Town of Hilton Head Island Regular Design Review Board Meeting

February 23, 2016

AGENDA

HARBOURSIDE: ELEV. FRAME (WEST) SCALE 1/2"=1'-0"

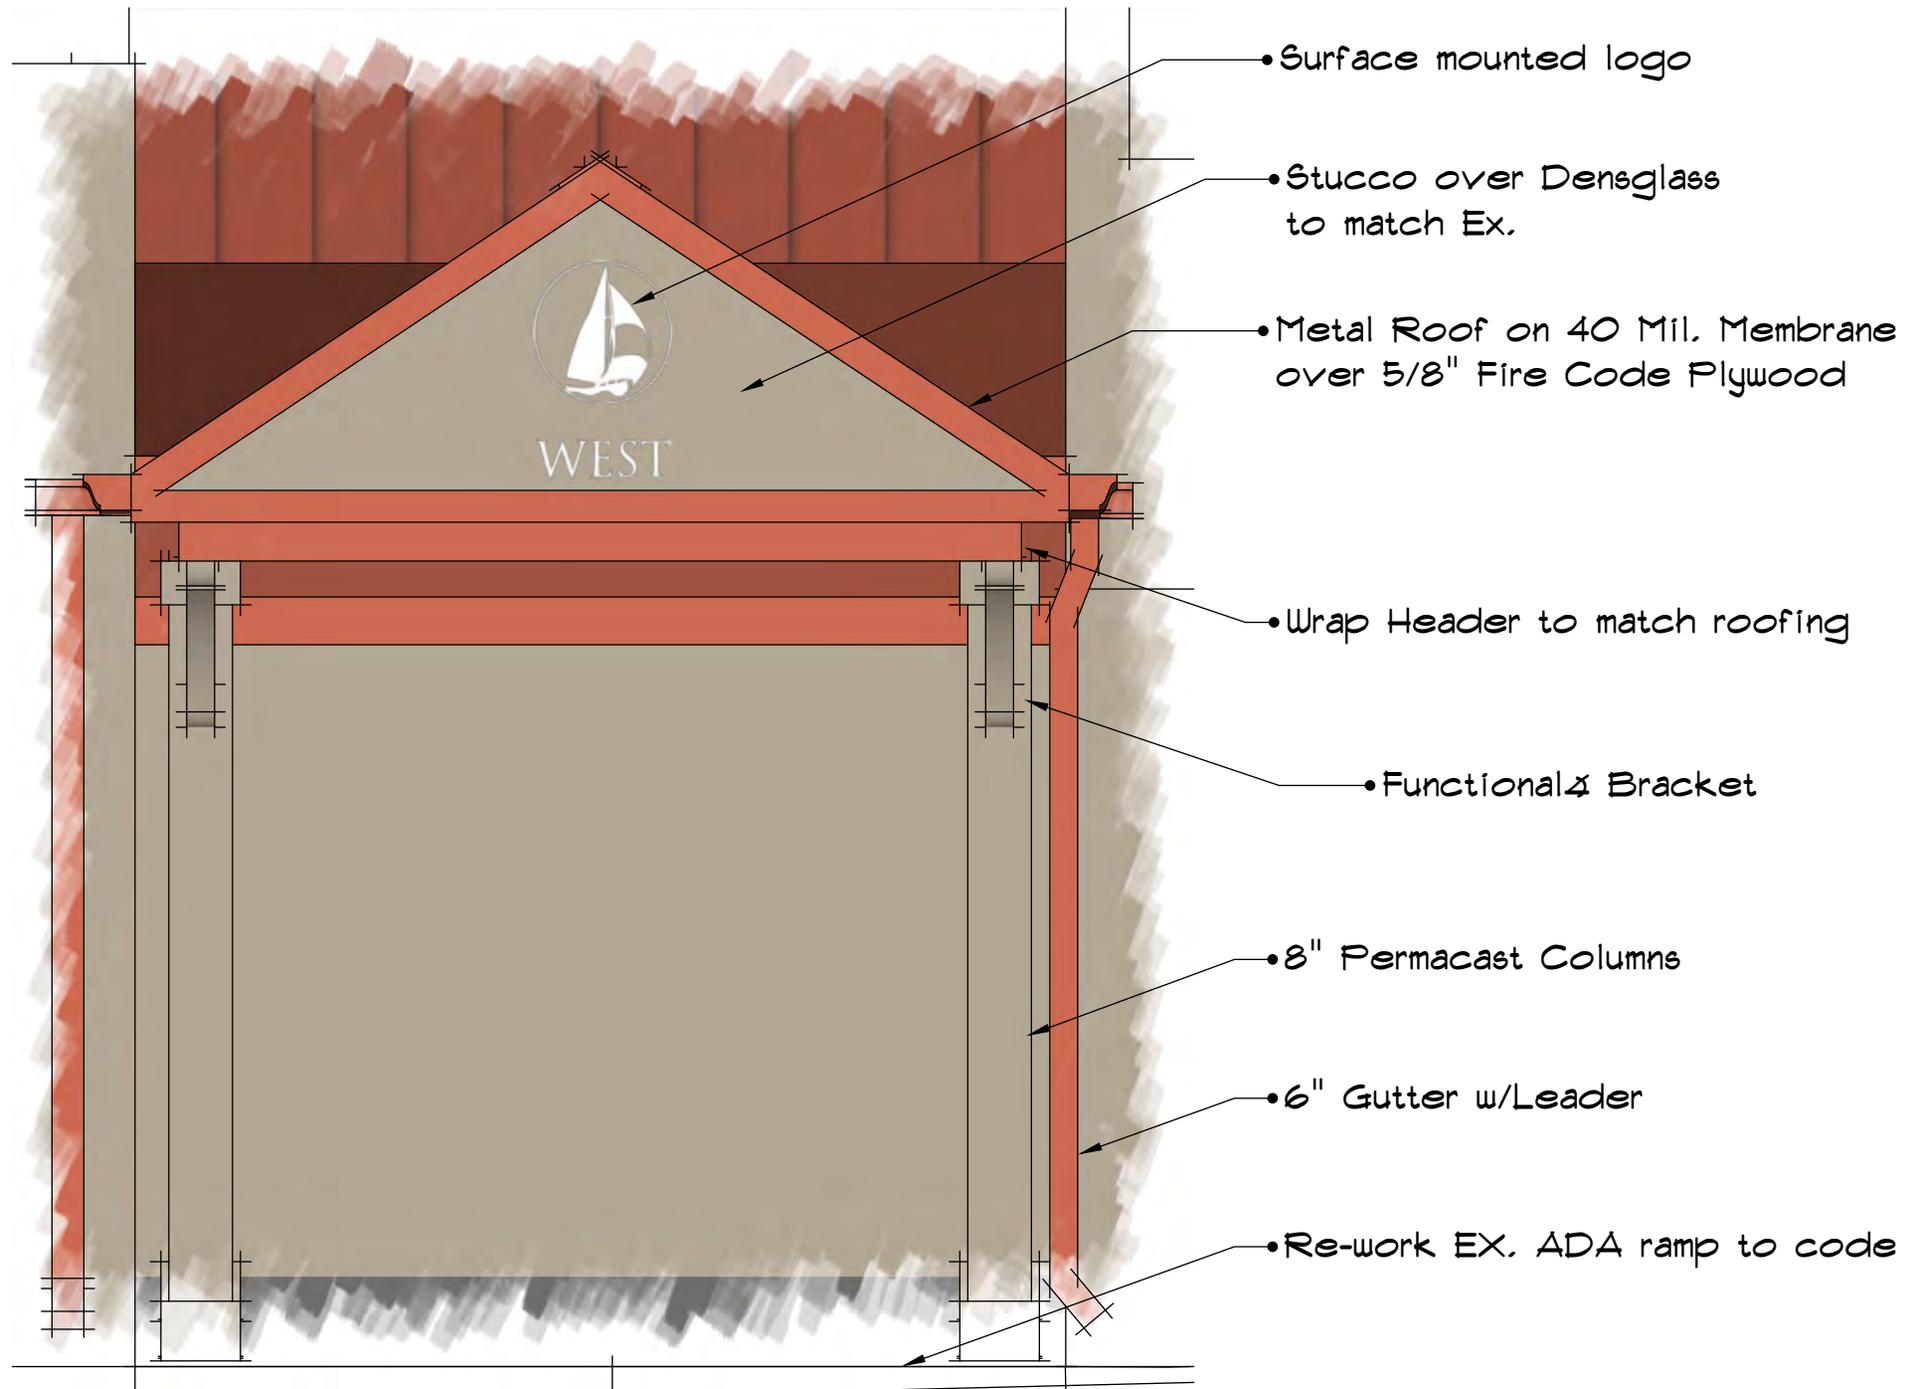
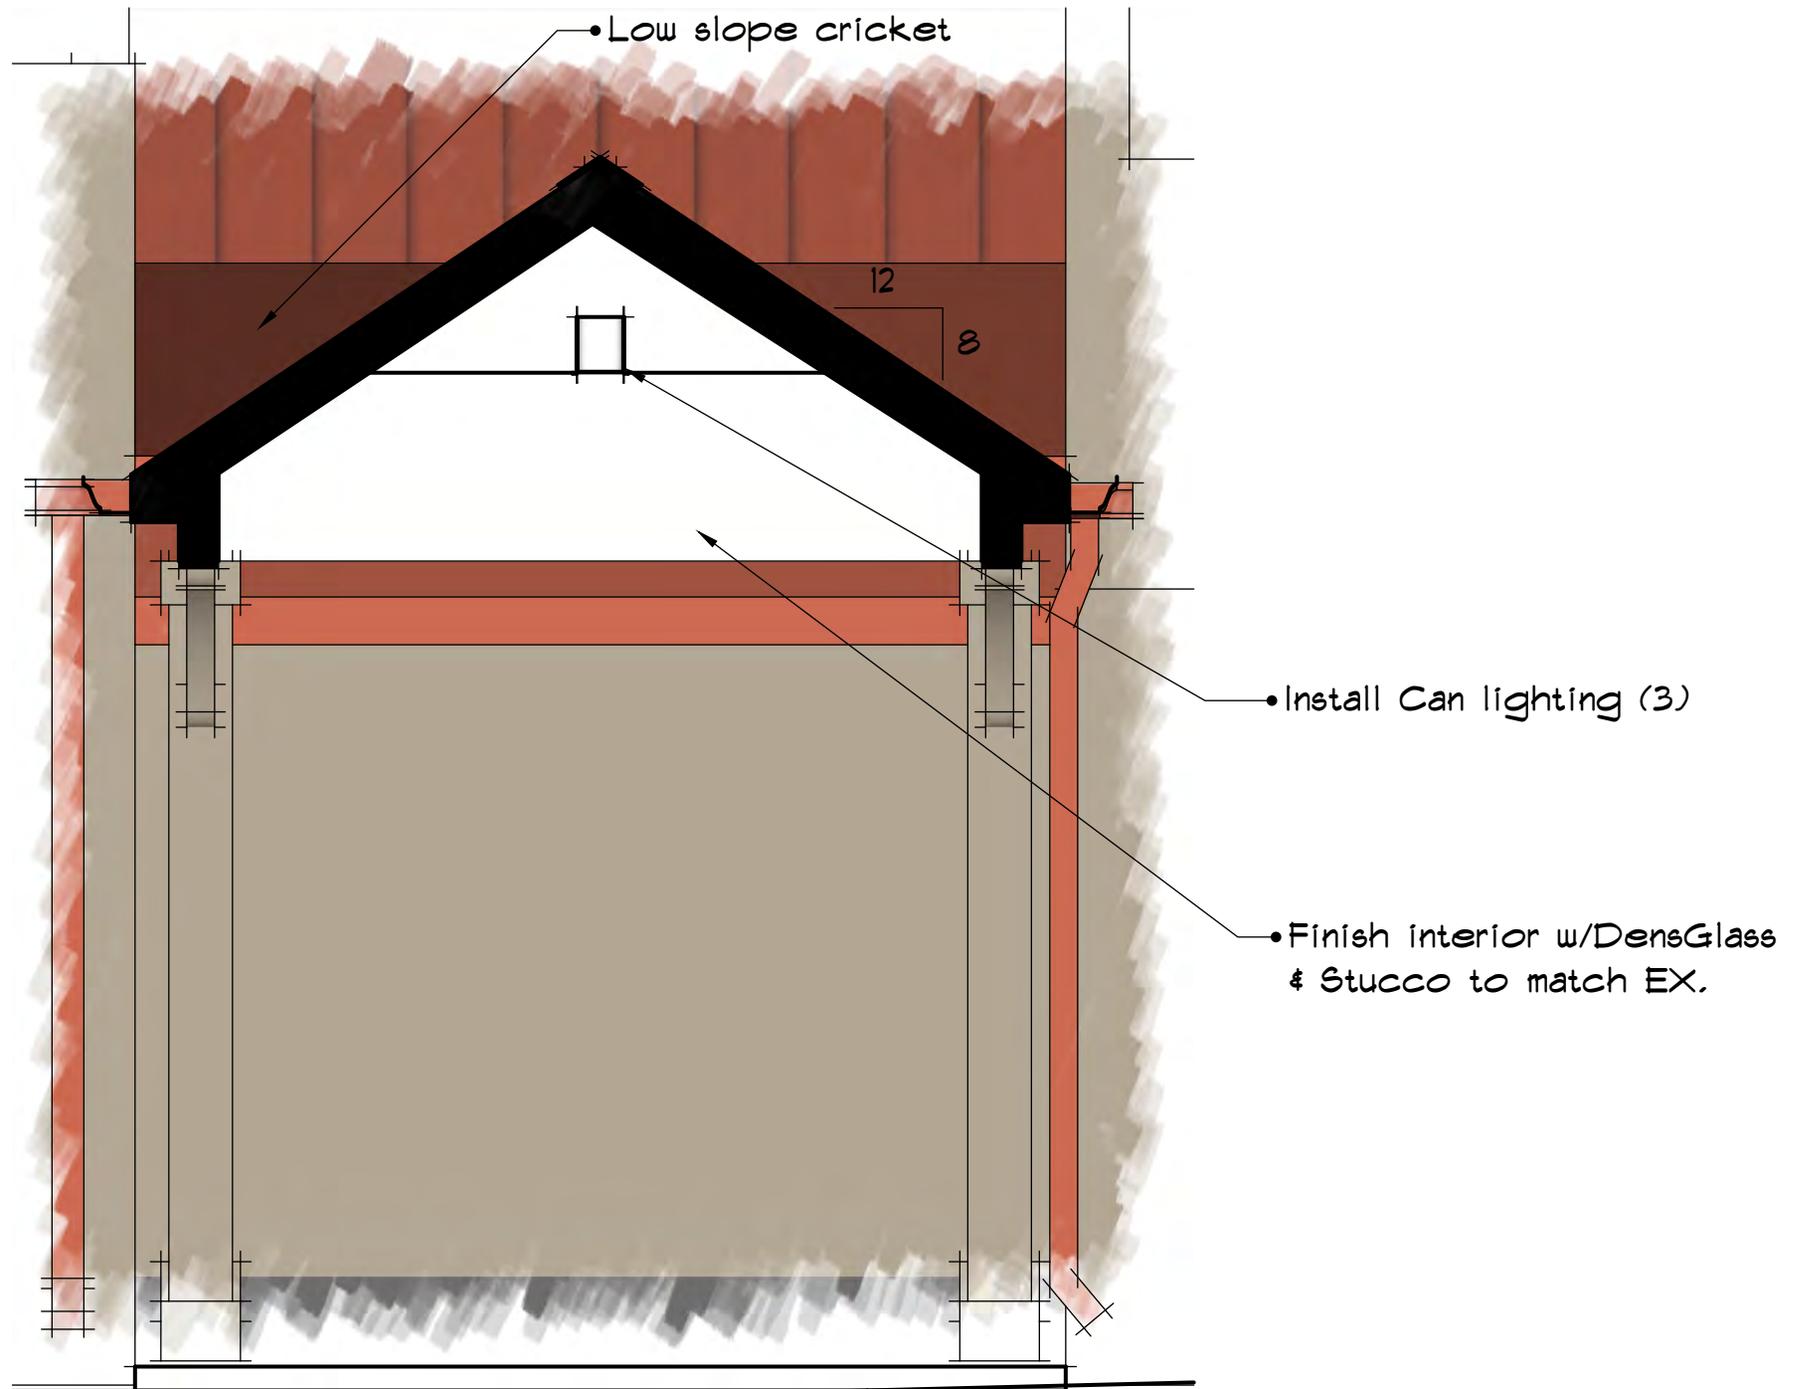
Applicant proposes to replace existing canvas awnings to match roof replacement. Colors (terra cotta) and materials (stucco, wood, metal roof) are consistent with existing.

Floor Plan
 Foundation Plan
 Elevations

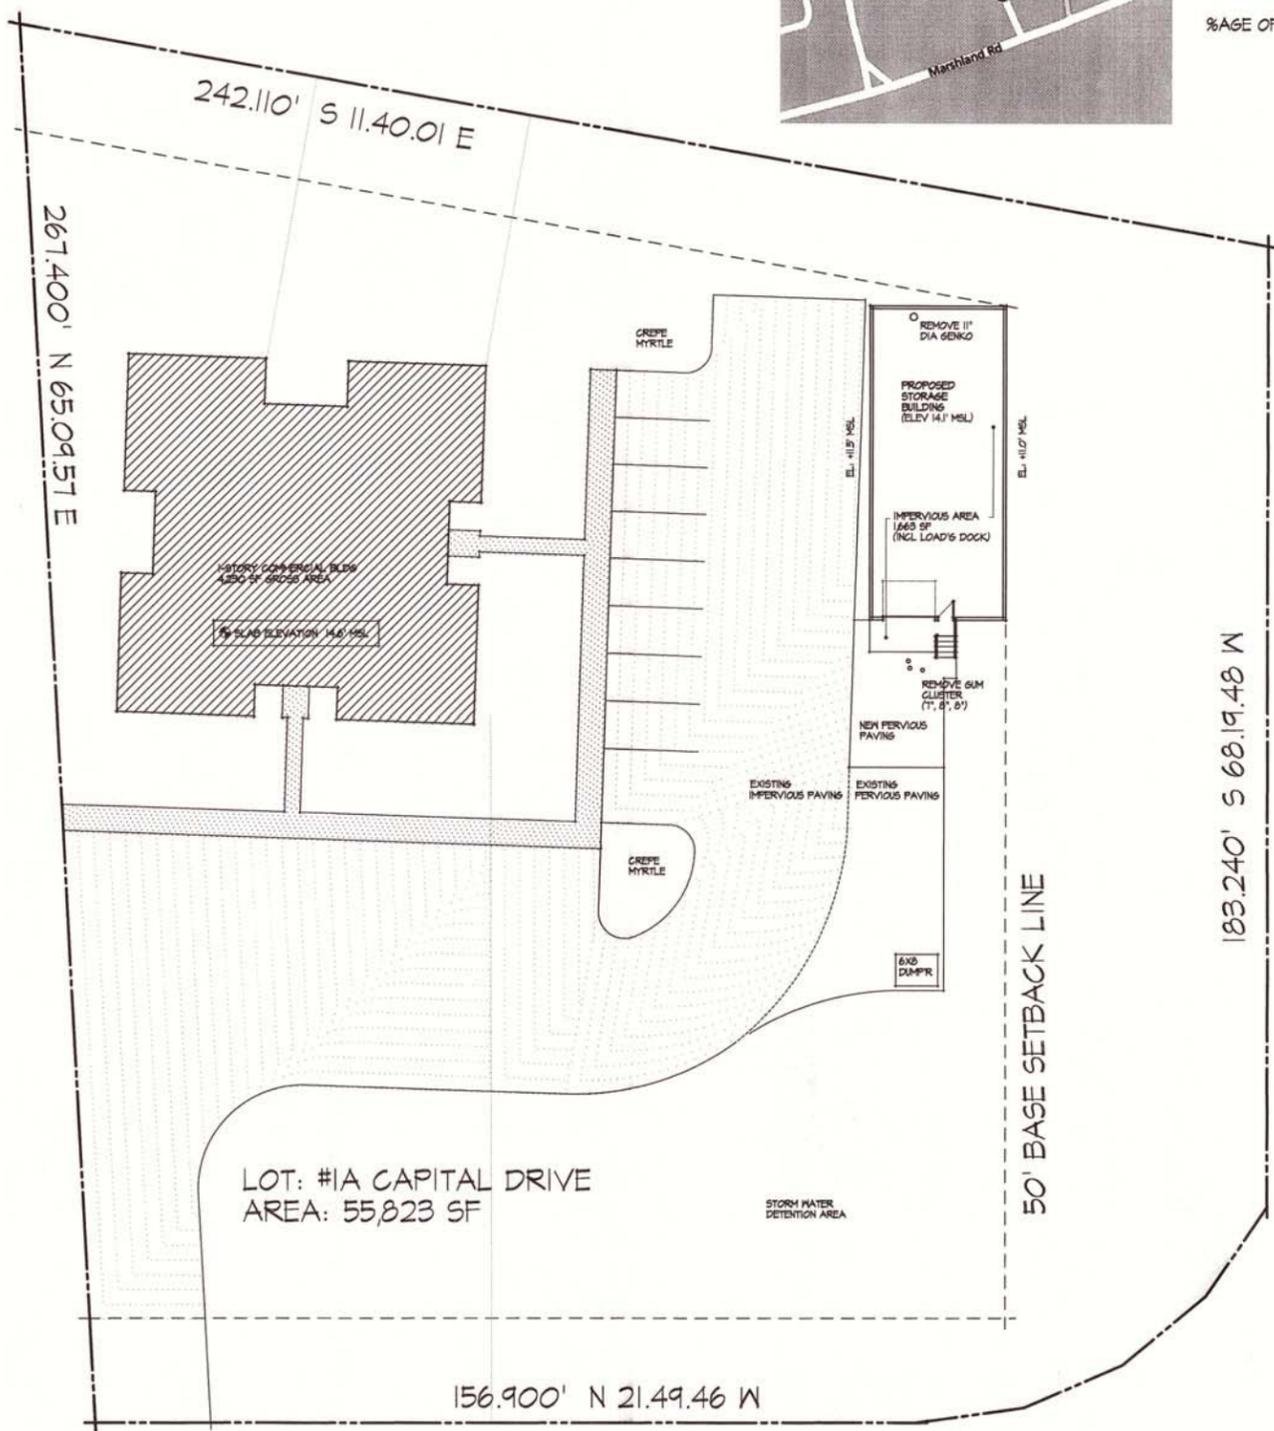
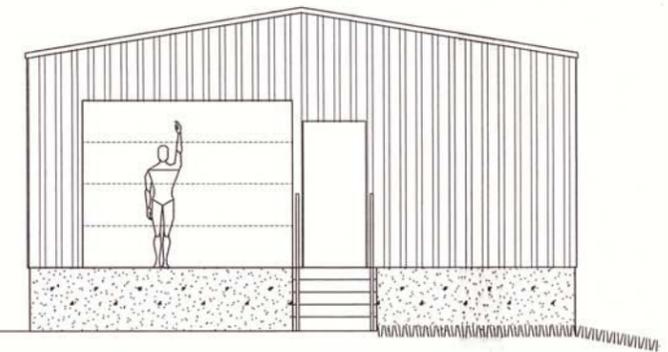
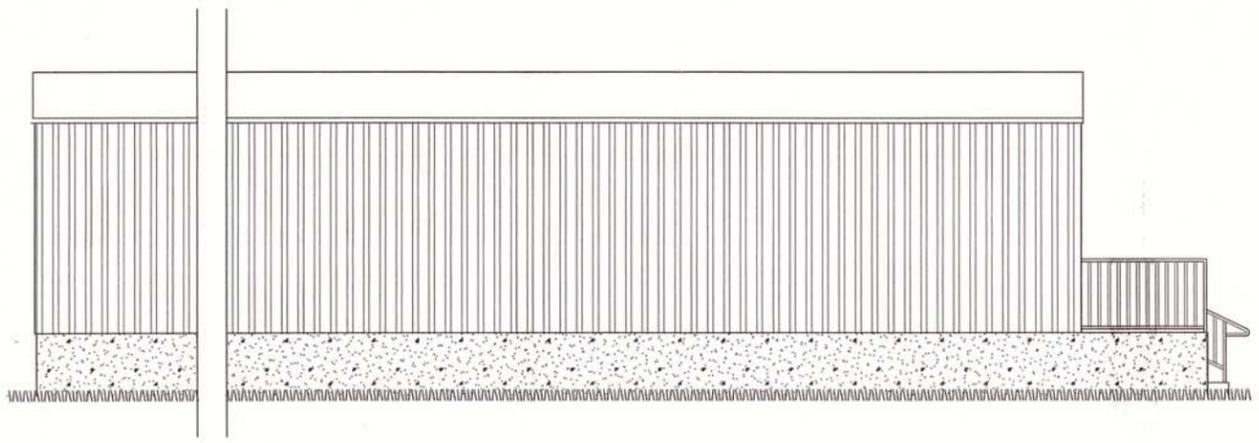
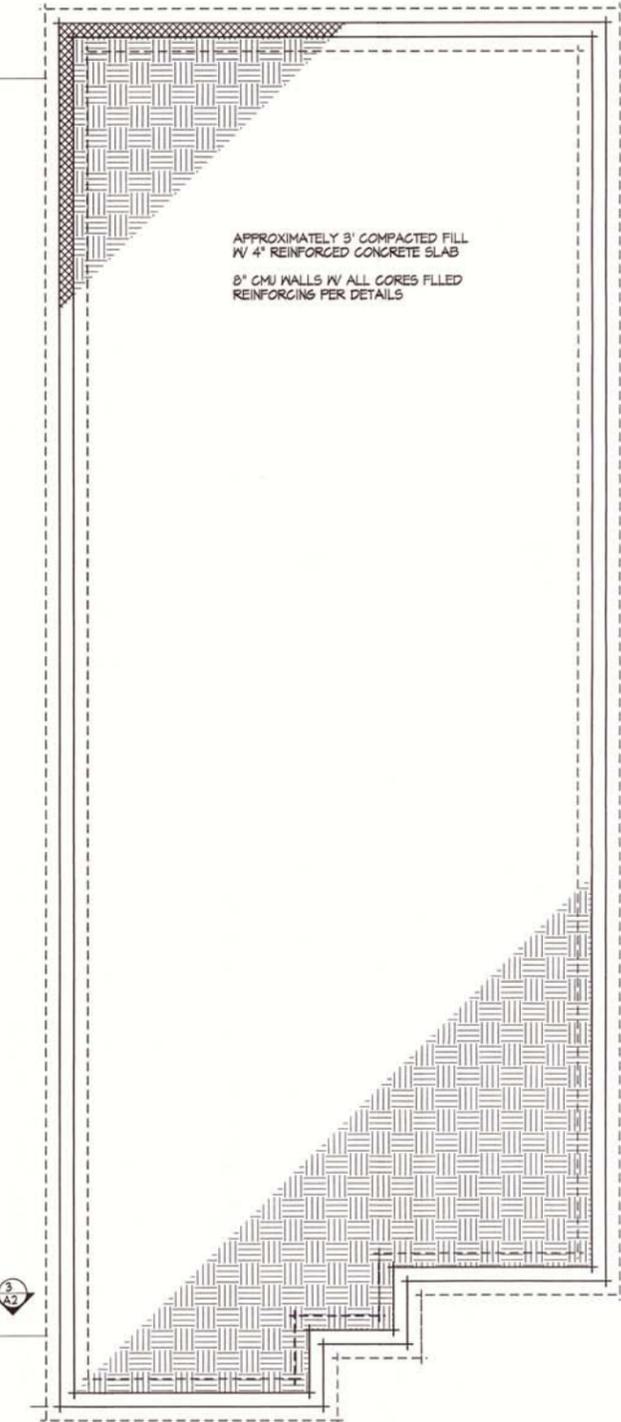
1. Provide landscape plan. Refer to LMO Appendix D: D-6.I for additional information.
 - a. Add landscaping, i.e. evergreen shrubs, in Marshland Road buffer and between parking lot and storage building.
 - b. Shift storage building toward Marshland Road (without impacting 40' setback) and add landscaping between edge of parking and storage building.
2. Restudy building façade and address requirements of overhangs and unrelieved repetition.
